Product Change Notification

Change Notification #: 117067 - 00
Change Title: Intel® Server System R2312WF0NP,
Intel® Server System R2308WFTZSR ,
PCN 117067-00, Product Design,
3.5" Tool-Less Carrier Design Improvement
for 2.5" Drive Support
Date of Publication: July 17, 2019

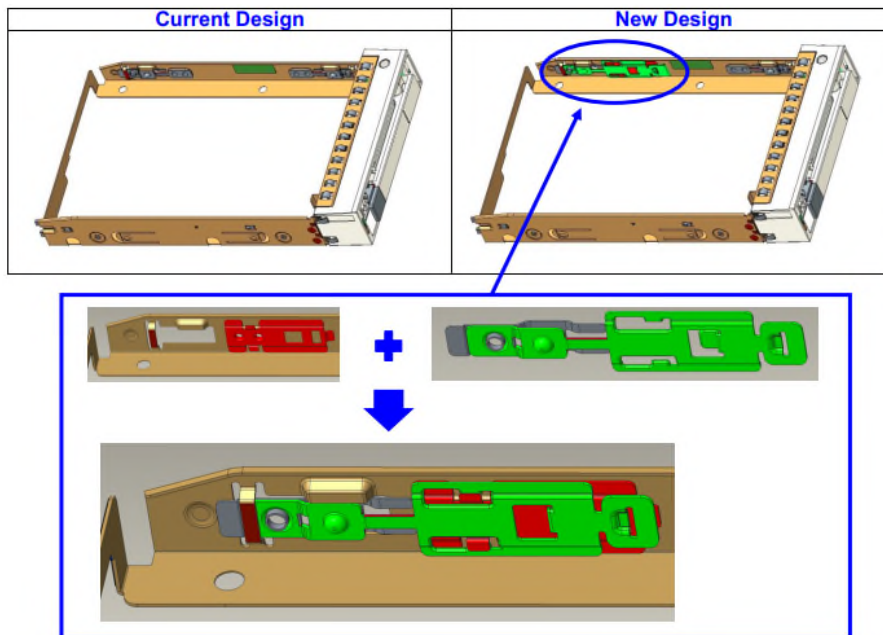
Intel is implementing an improvement on servers listed in the products affected table for the 3.5" tool-less drive carrier for 2.5" drive support, new rear spring (see image in green) and new spring holder (see image in red) attached to the tool-less drive carrier. Removing the rear spring of 3.5" tool-less carrier when Install 2.5" SSD drive, installing the rear spring to support 3.5" HDD.
